## Petition R16-05 Ervin Cook Road Conditional District Rezoning

### PART 1: PROJECT SUMMARY

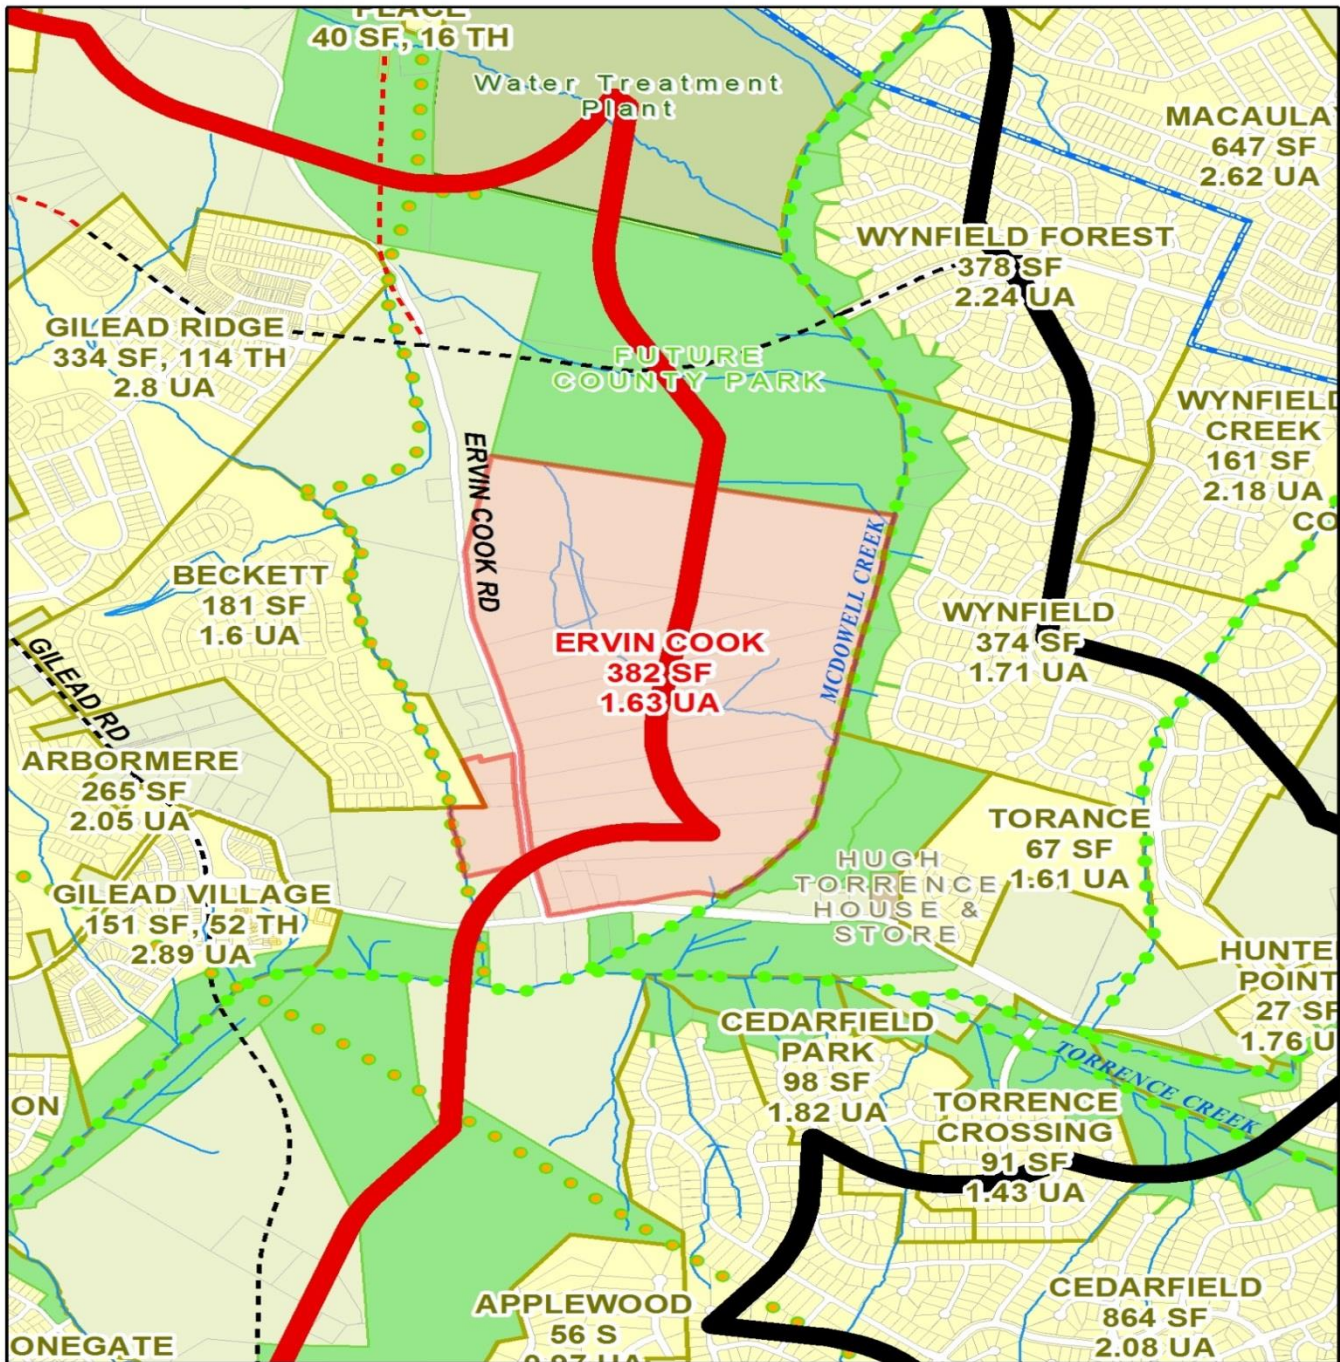
- Comment: The proposed CD Rezoning is split by the “High and Low Intensity Areas” line from the 2030 Community Plan (see map below). The eastern half of the project is located within the area between the High and Low Density line and the western half (along Ervin Cook Road) is located outside of the line.

- Comment: The proposed Ervin Cook Road subdivision has a density of 1.63-units per acre. The surrounding developments average 2.08, as shown on map below:
